Digicel's comments

**The Office of Utilities Regulation Supplementary Consultation
Document**

**Cost Model for the Assessment of Fixed Infrastructure Sharing
Rates**

8th October 2021

Figure 1

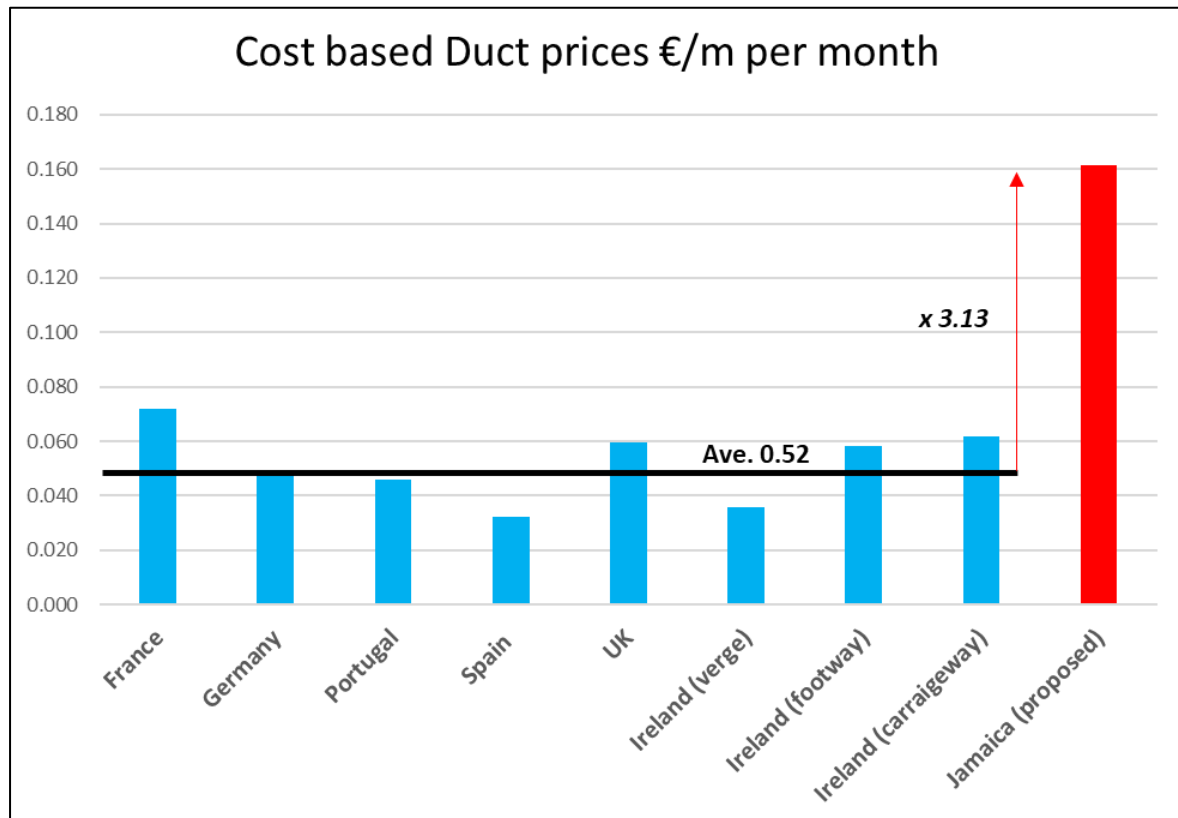
From **Figure 1** we can see an alarming gap is observable between comparator set prices with proposed rental rates in the draft Jamaican³ model. In fact the Axon model is generating outputs more than 3 times the average of benchmarks from other jurisdictions. While some differences is to be expected from country to country, it is nevertheless notable that the standard deviation of the comparator set of rates is just **€0.013** for a sample of countries that varies significantly from a topological, population density and climate perspective which means despite material differences in the characteristics of these countries the delta in cost-based duct estimates across the set is relatively narrow.

Figure 2

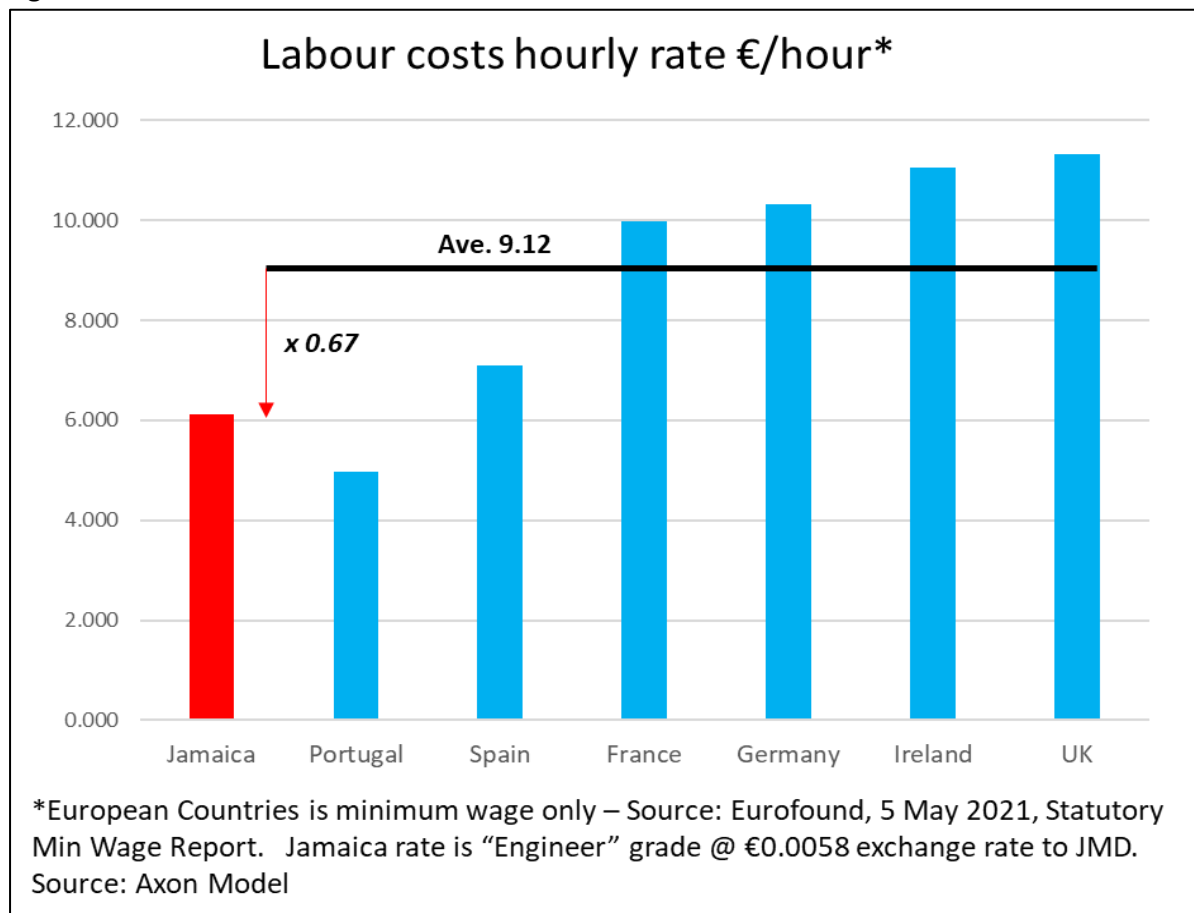
Looking at a more detailed a comparative assessment by considering labour costs⁴ – a major component of trench/duct/subduct unitary pricing⁵ – the breath of the gap observed in **Figure 1** becomes even harder to justify. Using just the minimum wage from the countries included in **Figure 1** above (and it is reasonable to assume engineers would likely earn a significant premium over the minimum wage in those countries) against the hourly engineering wage⁶ identified in the model, we can see (**Figure 2**) that not only can the comparatively very high Jamaica duct prices not be explained by labour cost discrepancies, this variable in fact would put downward pressure on model outputs if actual data versus “international benchmarks” of unitary capital costs were used.

This evidence suggests that at the very least some degree of **normalisation** should be applied to International Benchmarks Axon are using to reflect these material discrepancies if labour costs in the benchmarked countries exhibit similar wage deltas. It is important to again stress that only minimum wage statistics are used for the European comparator set with qualified engineer staff in those countries likely to earn a significant premium above minimum wage. It would not be a difficult task for Axon to carry out a labour cost comparator assessment between Jamaica and its benchmarked sources to establish an appropriate normalisation factor for at least the labour intensive input prices (e.g. trench costs).

Figure 3

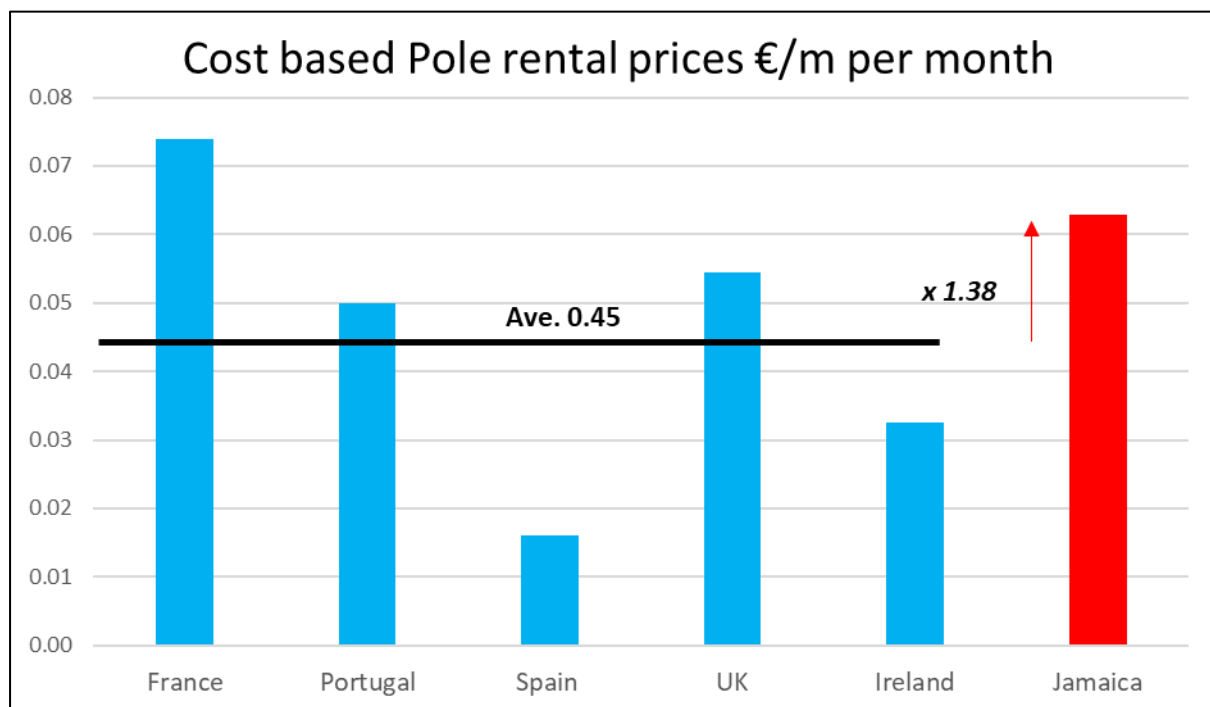
Turning then to the a high level assessment of pole rental prices (**Figure 3**)⁷, again with a European comparator set we can see that while the significant delta observed in relation to Jamaican duct prices is not present here, it nevertheless remains on the high side which again raises concerns about the appropriateness of the asset input prices used in the model and further compounds an argument on the need for the application of normalisation factors to the international benchmarks being used by Axon. In the event that this exercise has already been carried out then the discrepancies observed requires some explanation or alternatively other aspects of the model need to be considered in greater detail.

It should be further noted that while the pole rental prices in the above analysis is on the high end of the scale for the comparator set, given that price at least falls within of a range that is below the highest price in the set, this only serves to heighten concerns about the enormous gap observed on duct prices in **Figure 1**. This is because if Jamaica were *genuinely* such a significant outlier in relation to duct pricing, then one would expect to see a similar trend in relation to pole prices. It is much more likely however (particularly based on labour cost analysis), that the true cost of duct rental in Jamaica should be materially lower. If following on from this latest review of inputs that the model continues to demonstrate the current **exceptional premium** over international comparators then this requires a comprehensive explanation from Axon and the OUR.

Figure 4

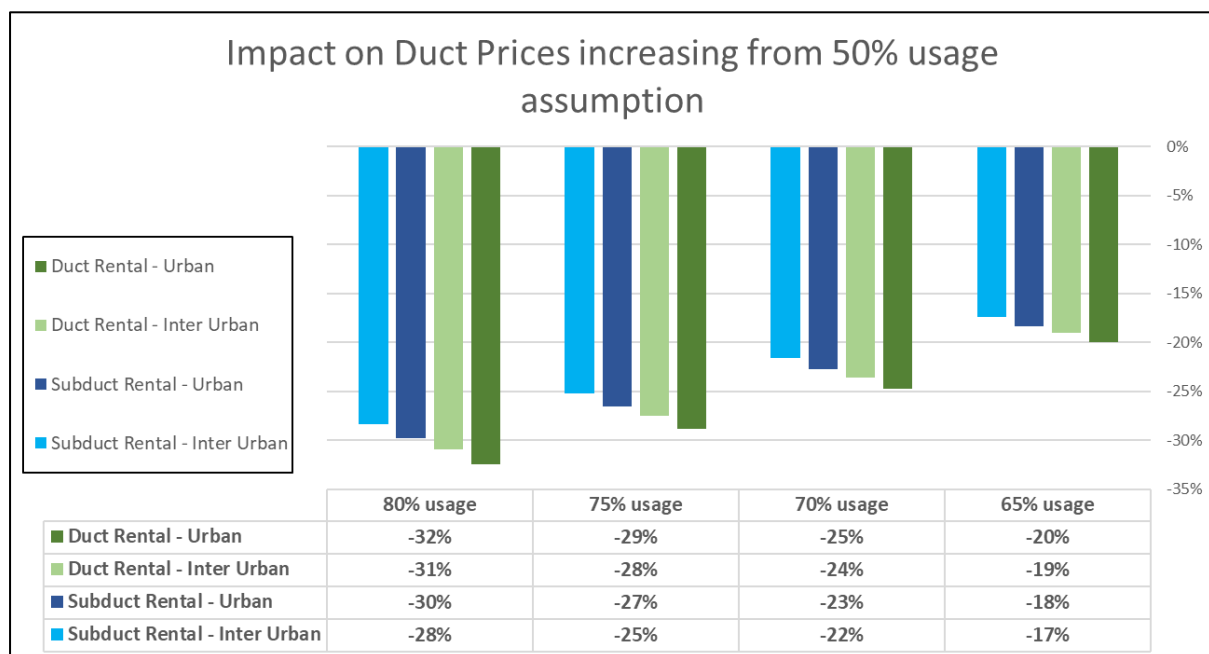
Figure 4 provides a sensitivity analysis of the impact on duct prices where more reasonable usage assumptions are applied. For example, increasing usage from **50%** to **65%** would result in as much as a 20% reduction in the output prices.

Figure 5 – CMT Original Chart

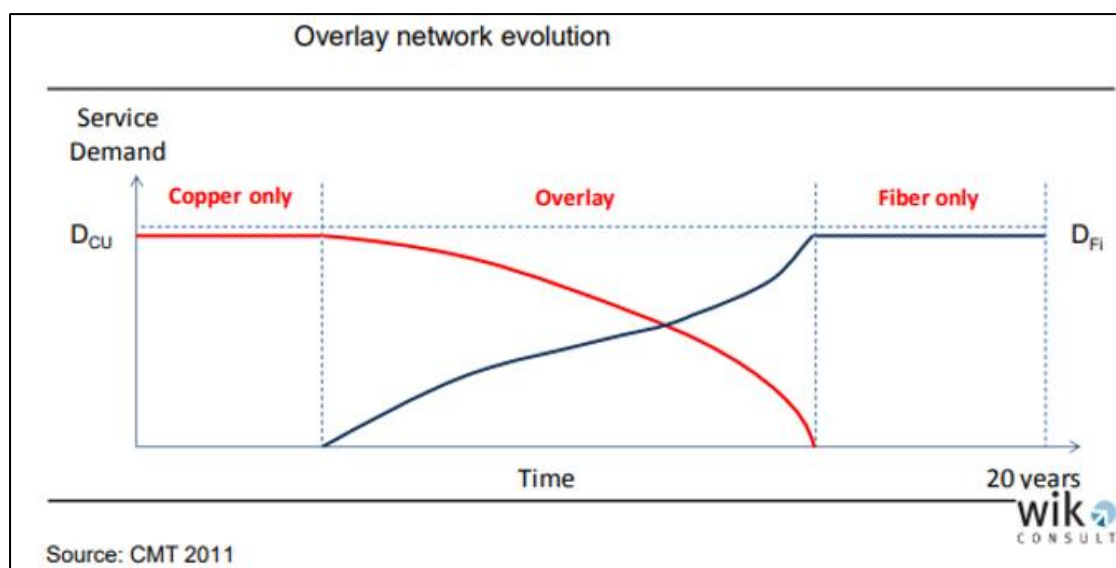
It is critical that fair proportion of duct/subduct pricing is attributed to copper services. In this regard we refer to the approach taken by the Spanish regulator (CMT) when it built its initial infrastructure model in 2012. CMT determined that *"the initial copper demand and the final fibre demand will be used to dimension the required civil infrastructure. The costs assignable to each of these infrastructures will be assigned appropriately according to the duct space consumed"*¹³ [emphasis added]. We reproduce in **Figure 5** a graphical representation of this approach to the CMT modelling exercise. The Jamaican model has not been developed to allow for a shifting copper to fibre dynamic over time but nevertheless should be able to apportion a greater allotment of duct/subduct costs to copper services where cable volumes are increased in the model (even where underground fibre is held at zero).

Figure 6

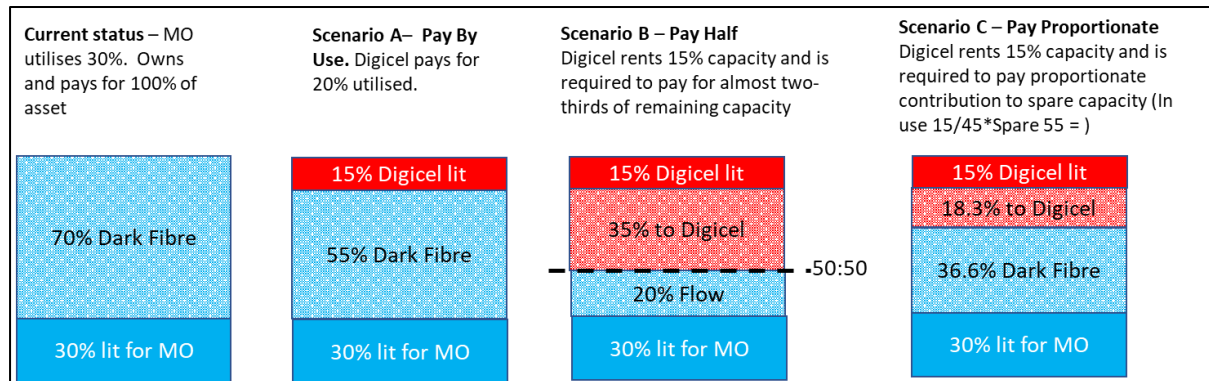
In practice how **Scenario C** would be applied using the current outputs of the model which indicates the rental cost associated with 1Km of Urban dark fibre would equate to **JMD\$ 7,729** per year, Digicel contribution to this cost would be $\text{JMD } 7,729 \times 0.333\% = \text{JMD } \$ 2,576/\text{Km}$ of rented dark fibre.
